### APPEAL SUMMARY

**Appeal ID:** 19034

**Project Address:** 1715 SW Salmon St

### **Alternate 2 hour fire rated beam assembly with engineering analysis: Granted as proposed.**

EXHIBIT 1 - TYPICAL FLOOR FRAMING PLAN

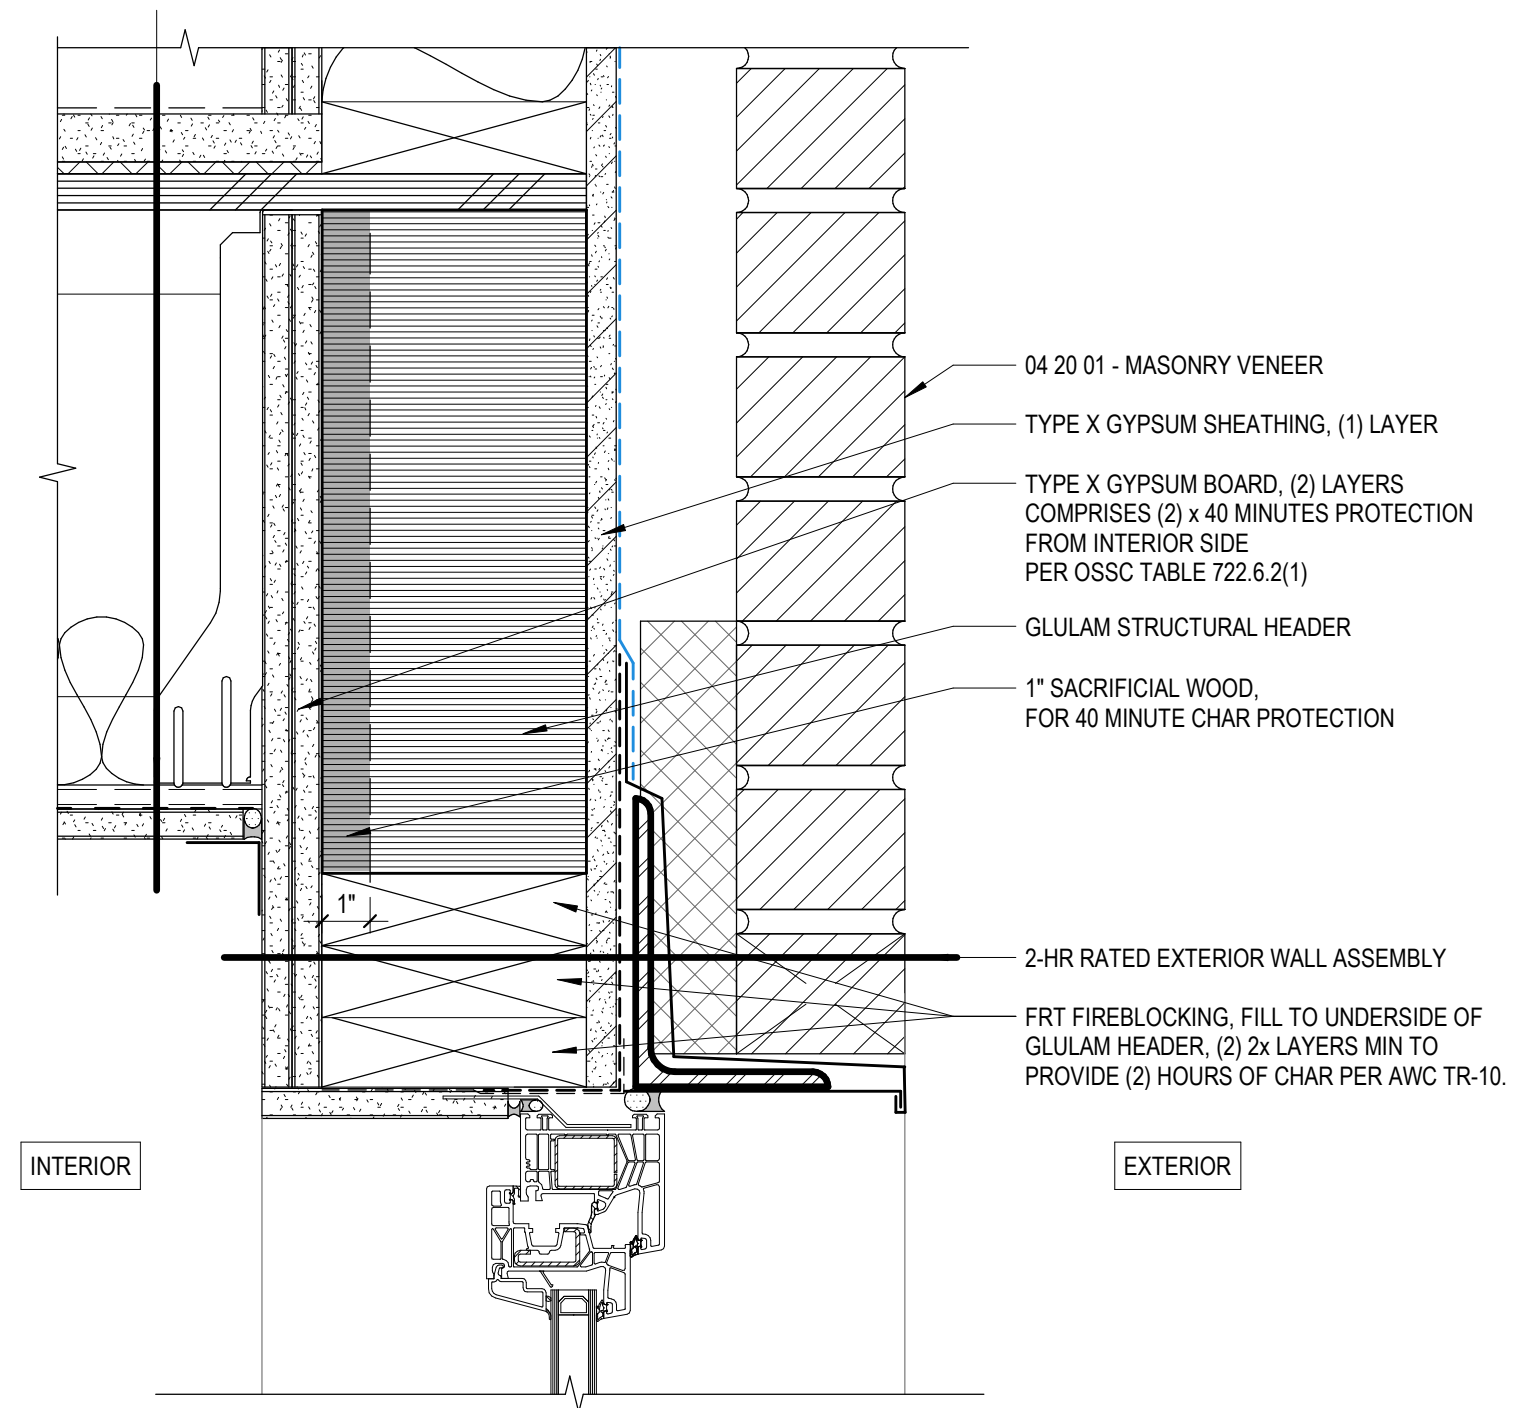
The building consists of Type III-A construction using FRT wood framing at the exterior walls over a I-A concrete podium. The building is provided throughout with an NFPA 13 sprinkler system. In specific locations glulam headers enclosed within the 2-hr exterior wall assembly are required to

span openings. Please reference attached framing plan for highlighted locations (see Exhibit 1). The glulams are not available as factory FRT treated.

## UPDATED EXTERIOR HEADER CALCULATIONS

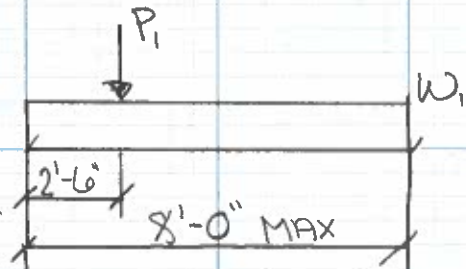
1" of sacrificial wood at the interior face of the header. Per AWC TR-10 the assumed char rate of softwood is 1 ½" per hour. This yields 40 minutes of fire protection from 1" of char. Refer to Exhibit 3 for structural calculations showing the design of the headers with a 4 ½" width, and specified as a 5 ½" width to provide for 1" of char.

• USE 5 1/2 x 13 1/2 GL

RAN AS 4 1/2 x 13 1/2 GL FOR CHAR RATING

• USE 5 1/2 x 15 GL

RAN AS 4 1/2 x 15 GL FOR CHAR RATING
